SEWAGE DISPOSAL SYSTEM
HOWARD COUNTY HEALTH DEPARTMENT
BUREAU OF ENVIRONMENTAL HEALTH
410-313-2640

P 515305 - A

A REPAIR

SUBDIVISION Clarksville Ridge LOT NUMBER 6 ADDRESS 6600 Whitegate

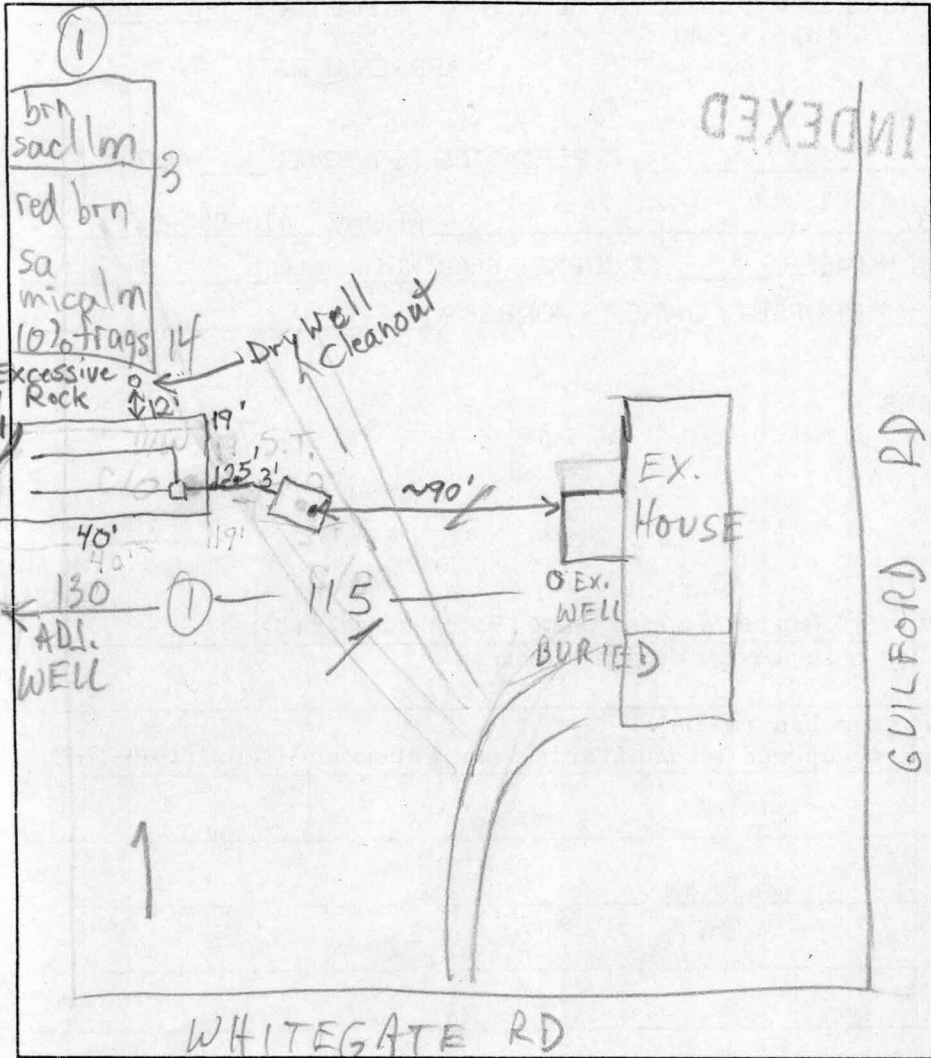
INSPECTION COMMENTS: 8/15/01 Drywell disconnected but left intact for potential future use. Will have to be abandoned if public sewer becomes available. Inlet depth for bed was greater than 4' in areas to be able to use gravity from tank to box. To go to put new 6" cleanout on septic tank. O.K. to cover everything. One corner of bed contained excessive rock and wasn't used. BB
